Final Plat
SUBDIVISION REPORT

SUBDIVISION COMMITTEE
METROPOLITAN AREA
PLANNING COMMISSION

S/D No.: 86-36 Name: GOLDEN HILLS 2ND ADDITION

Re: S/D 86-36 - Final Plat of Golden Hills 2nd Addition.

GOLDEN HILLS 2ND ADDITION

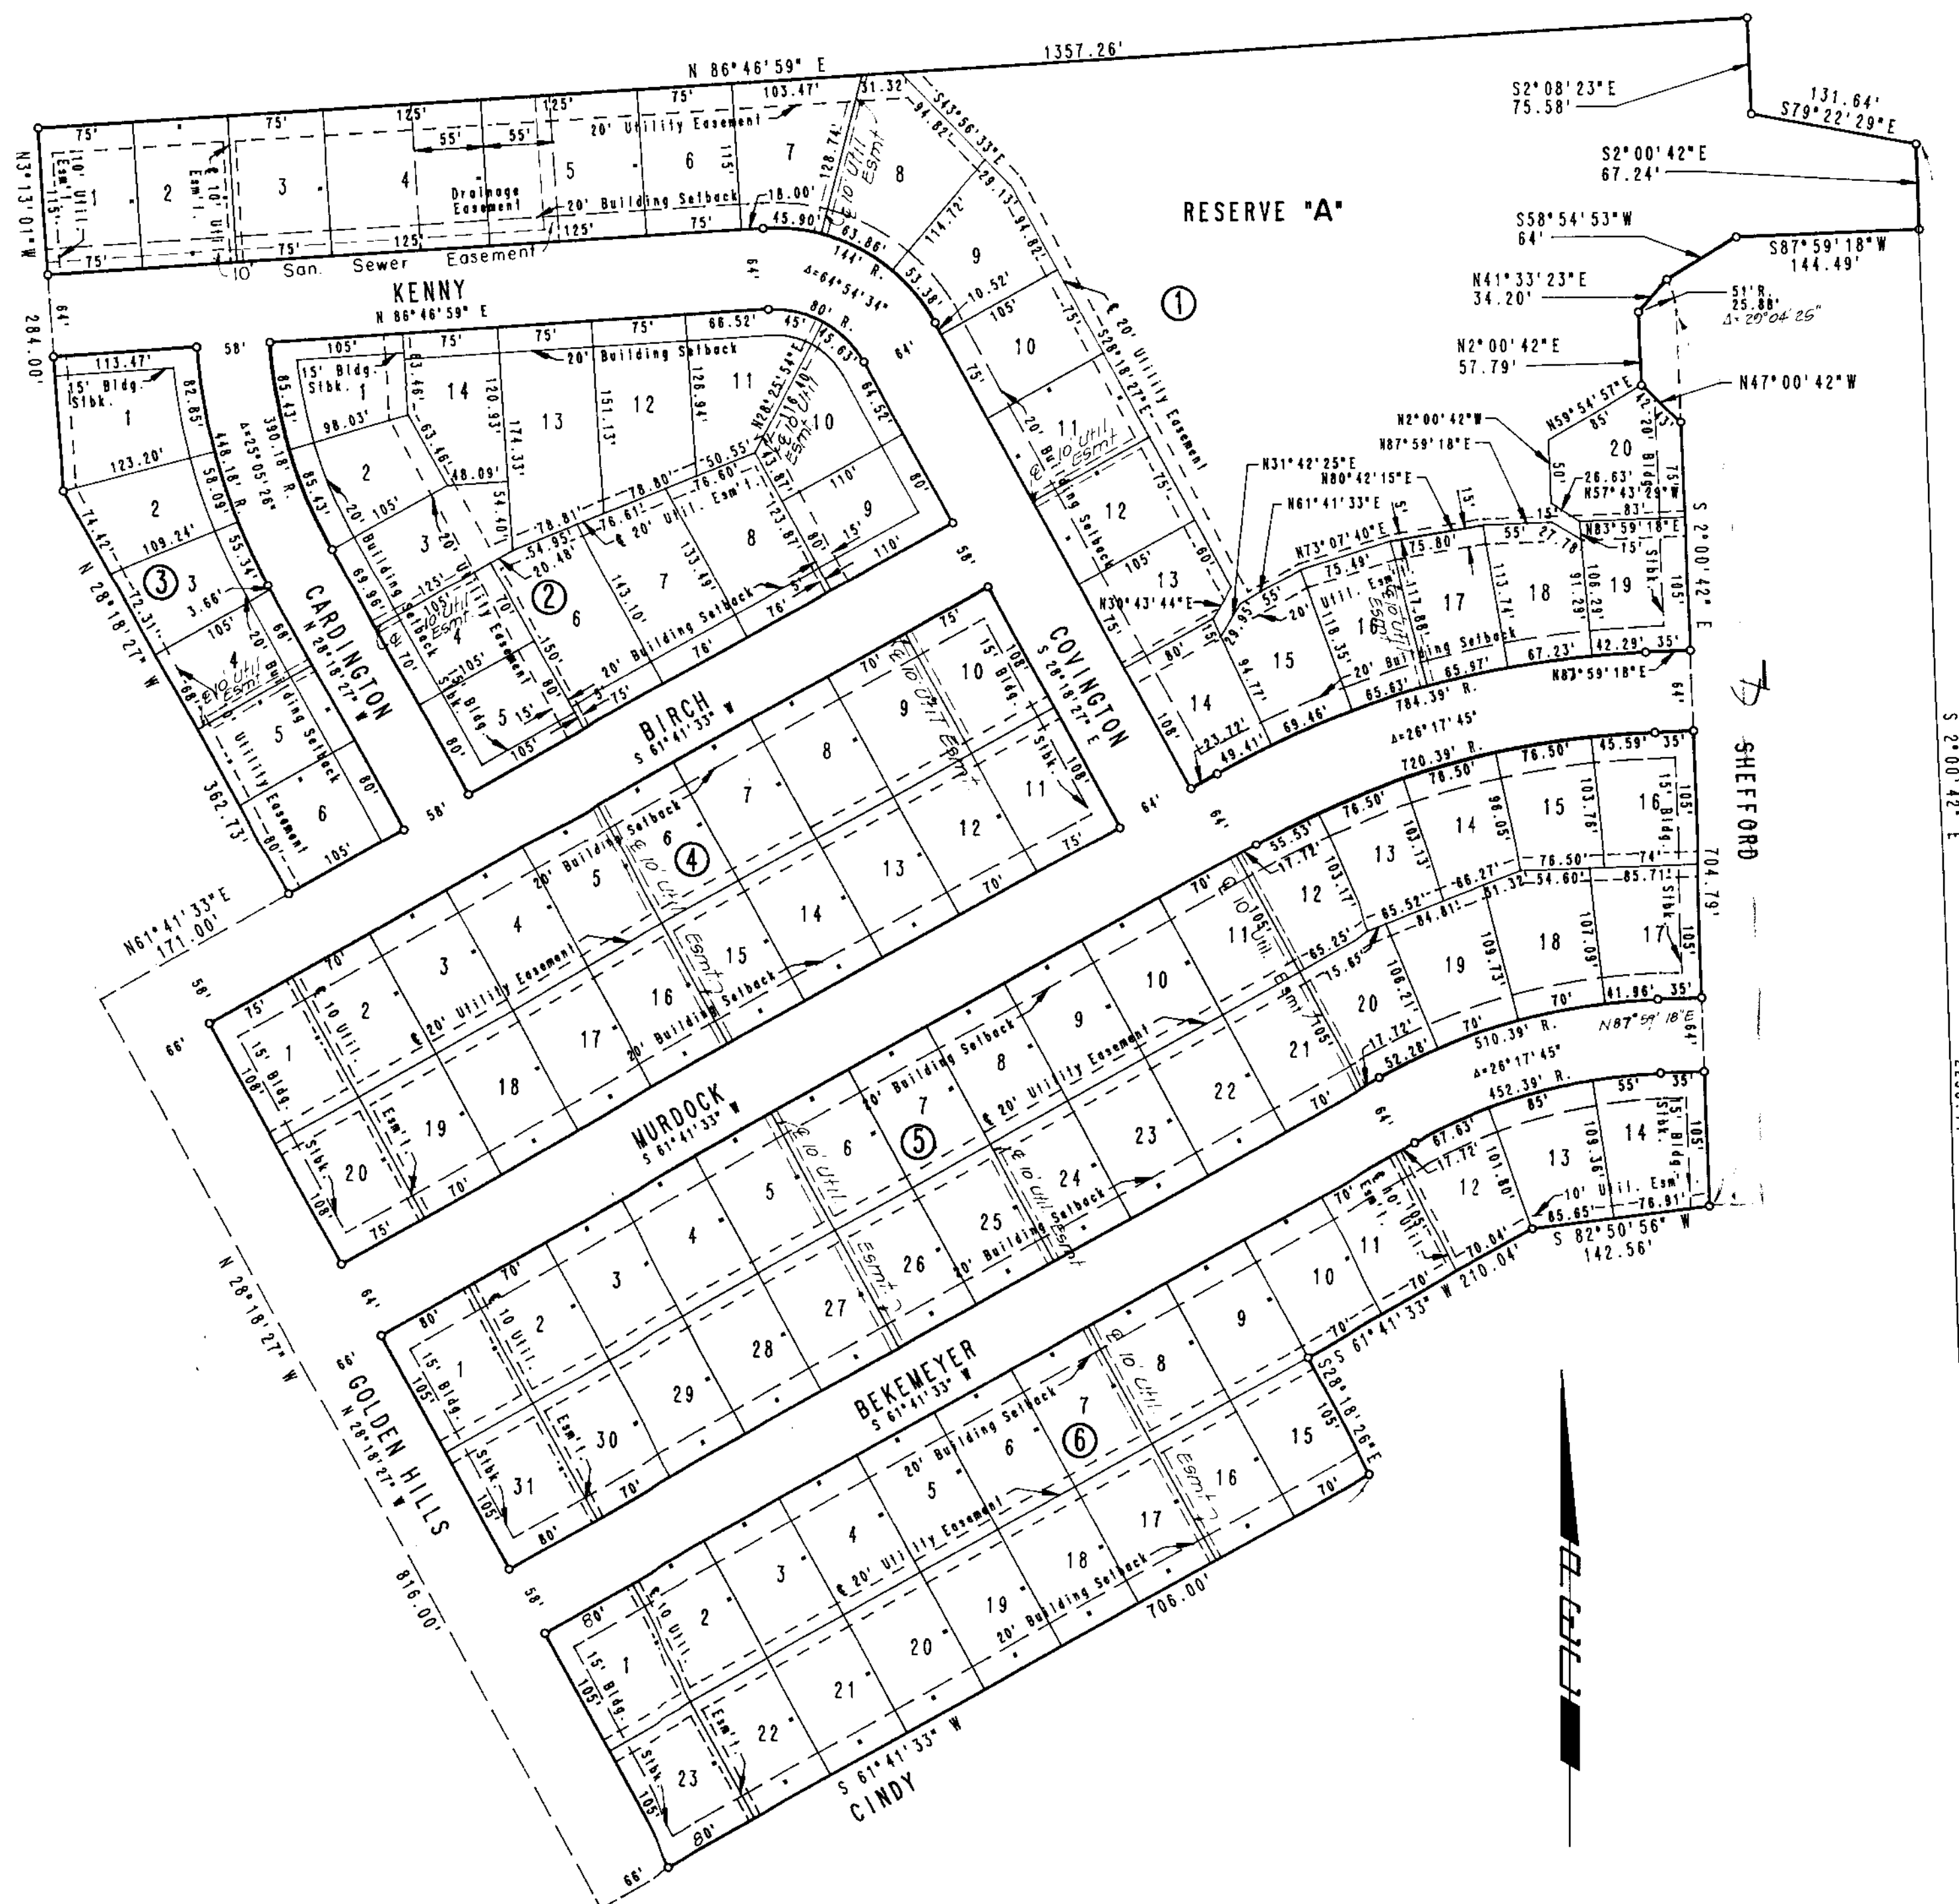
- L. The applicant shall submit a covenant which provides for four (4) off-street parking spaces per dwelling unit on each lot which abuts a 58-foot street. The covenant shall inventory the affected lots by lot and block number and shall state that the covenant runs with the land and is binding on future owners and assigns.
- M. On the final plat tracing, the centerline of adjacent Shefford Street shall be labeled adjacent to the east line of this plat. A half-street right-of-way dimension shall also be provided.
- N. Perimeter closure computations shall be submitted with the final plat tracing. Section 5-101(C).
- O. Recording of the plat within 30 days after approval by the Board of City Commissioners.
- P. The representative from the City Engineer's office should be prepared to comment on the status of the applicant's drainage plan.

- A. The applicant shall guarantee the extension of sanitary sewer to serve the lots being platted.
- B. The applicant shall guarantee the extension of City water to serve the lots being platted.

- C. The applicant shall guarantee construction of the storm sewers required by this plat.
- D. The applicant shall guarantee the paving of the proposed interior streets.

- E. The applicant shall guarantee the removal of the existing structures which encroach into the utility easements and street rights-of-way being granted.

- G. The Golden Hills street paving petition shall provide for the construction of sidewalks on each side of this collector street.
- H. The applicant is advised that, if permanent recreational facilities (e.g., swimming pools, club houses, etc.) are planned to be constructed within the reserve being platted, the affected reserve should not be platted as blanket utility and drainage easements.

- I. Provisions shall be made for ownership and maintenance of the proposed reserve. The applicant shall either form a lot owners' association prior to recording the plat or shall submit a covenant stating when the association will be formed, when the reserve will be deeded to the association and who is to own and maintain the reserve prior to the association taking over those responsibilities.

- J. Since Reserve A is being platted for drainage purposes, the required covenant which provides for ownership and maintenance of the reserve shall grant, to the City, the authority to maintain the drainage reserve in the event the owner(s) fail to do so. The covenant shall provide for the cost of such maintenance to be charged back to the owner(s) by a method similar to special assessments.

- K. The applicant shall obtain, by separate instrument, the off-site, 10-foot wide utility easement adjacent to the westerly line of Lots 1 thru 6, Block 3 and Lot 1, Block 1.
